## Planning Commission Staff Report

**SUBJECT:** Z13-12: REQUEST TO AMEND ORDINANCES NO. 1597 AND 1956 AND REZONE APPROXIMATELY 17.5 ACRES OF REAL PROPERTY WITHIN THE COPPER RANCH PLANNED AREA DEVELOPMENT (PAD), GENERALLY LOCATED SOUTH AND EAST OF THE SOUTHEAST CORNER OF WARNER AND RECKER ROADS FROM MULTI FAMILY-MEDIUM (MF-M) WITH A PLANNED AREA DEVELOPMENT (PAD) TO SINGLE FAMILY-DETACHED (SF-D) WITH A PLANNED AREA DEVELOPMENT (PAD) OVERLAY ZONING DISTRICT AND TO AMEND CONDITIONS OF DEVELOPMENT AS FOLLOWS: REDUCE LOT DIMENSIONS; DECREASE FRONT, SIDE AND REAR SETBACKS AND SEPARATION BETWEEN DWELLING UNITS; AND INCREASE THE MAXIMUM LOT COVERAGE FOR TWO AND THREE-STORY UNITS.

**Z13-12**

**Attachment 1: Notice of Public Hearing**

PARCEL B PROPOSED				
DESCRIPTION	QUANTITY	%	ZONING	GENERAL PLAN CLASSIFICATION
GROSS AREA	17.50 AC.		SF-D	RESIDENTIAL 5-8 DU/AC
NET AREA	13.21 AC.			
OPEN SPACE	4.46 AC.	34%		
GROSS DENSITY	6.23 DU/AC			
TOTAL LOTS	109 UNITS			
LOTS UNDER 3,000 SF	29 UNITS	27%

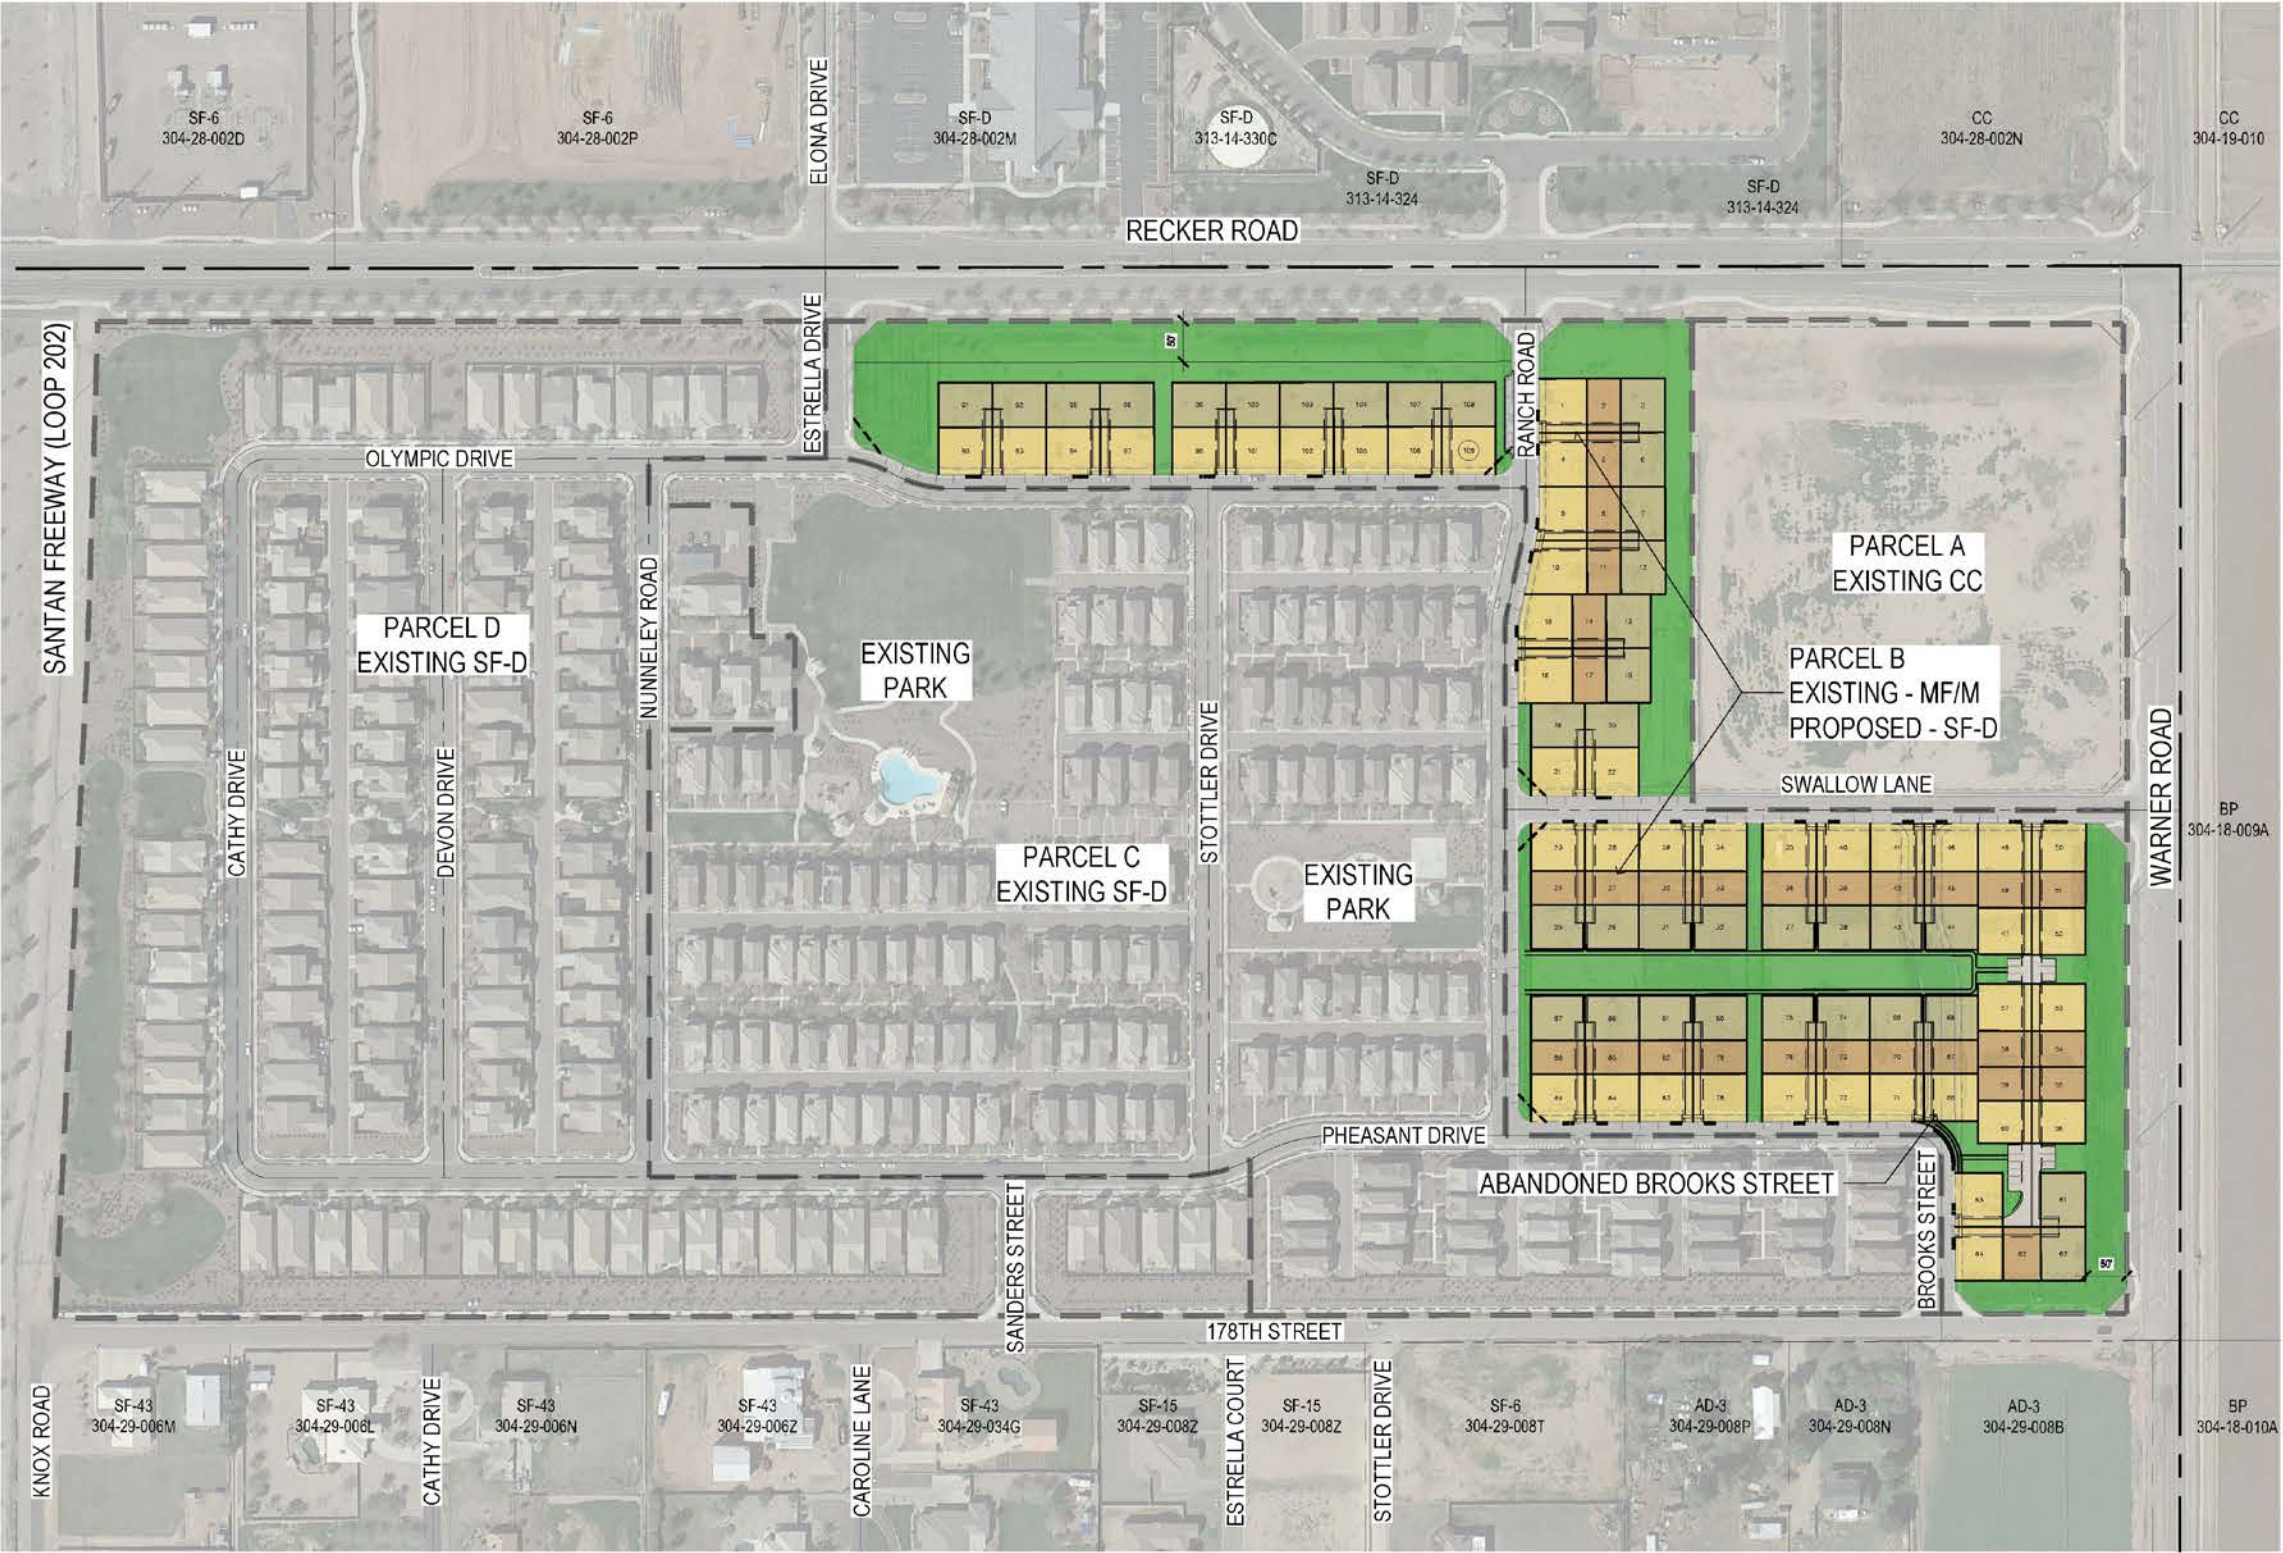
In review of the proposed Development Plan, the minimum lot size is shown at 2,620 square feet for 29 lots at the center of each pod. Per the preliminary plat exhibit, the remainder of lots range from 3,497 to 3,864 square feet. Staff is of the opinion that the smaller lot size illustrated on the Development Plan exhibit, should be limited to the 29 lots where a specific standard plan already fits.

The Single-Family Detached (SF-D) zoning district designation is the only district in this master plan community. The design for the use and benefit easement helps to maximize the use of the outdoor area for this lot layout. Staff is of the opinion that the intensity of the project will be relieved by observing the SF-D minimum standards in the LDC regarding lot coverage of 50% for the 2-story houses.

<b>Copper Ranch Parcel B</b>					
Zoning District	Min. Lot Area (Sq. Ft)	Setbacks			Coverage (%)
		Front	Sides	Rear	One/Two-Story
<b>Single Family-D (SF-D)</b>	<b>2,620 (for a maximum of 29 lots)</b>	<b>3'-6" for pod's end- lots only</b>	<b>3' 6" (measured to the face of the covered patio's post) and 3'</b>	<b>5'</b>	60%/ 50%

2. A minimum of **seven (7)** feet shall be provided between dwelling units measured from the exterior walls of the units.
3. The developer shall install the following improvements in the right-of-way to manage vehicular circulation and refuse collection functions:
  - Refuse pads shall be installed and have a minimum dimension of 3' x 3' with 2 feet in between each pad.
  - 'No Parking' signs shall be placed by the area of the designated refuse pads and there shall be a 15 foot clearance between refuse pad areas and the 1<sup>st</sup> on-street parallel parking space.
  - Each cluster of houses shall have a designated area by each driveway for monthly bulk trash service.
